**Report By:**

**Report: TAB Report**  
**Function: Test, Adjust, & Balance**  
**Date: 10/23/2025**  
**Completed By: National TAB**

**PROJECT**  
**01-19-26 QT #1431 TOLLESON, AZ**

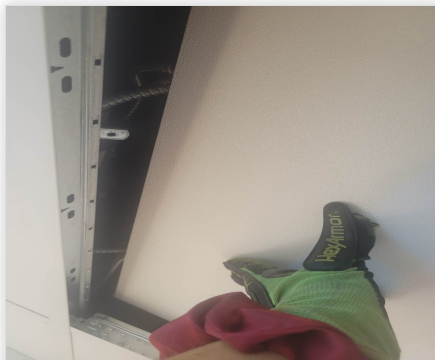
**Issue Name :** DAMPER LEFT OPEN, UNUSED DUCT  
**Description :** Duct open above ceiling. Recommend ensuring damper is closed before removing duct from use. This is noted because many stores have at least 1 duct branch removed.

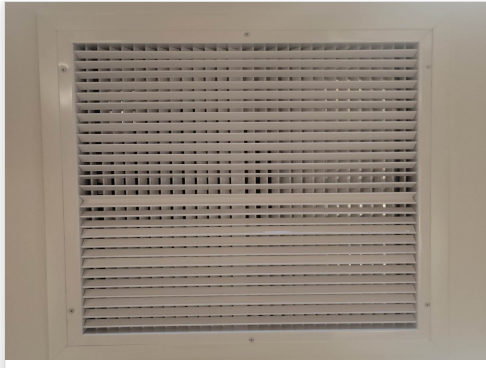
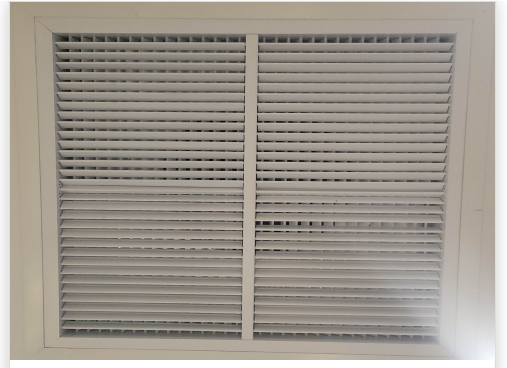
PICS OF GRILLE SHOW BEFORE AND AFTER. WHEN SET TO MSET DEPICTION, SMOKE LOSS WAS EXTREMELY HIGH MID-HOOD. HAD TO SET GRILLES ALMOST COMPLETELY OPPOSED TO HOOD TO OBTAIN 98% CAPTURE.
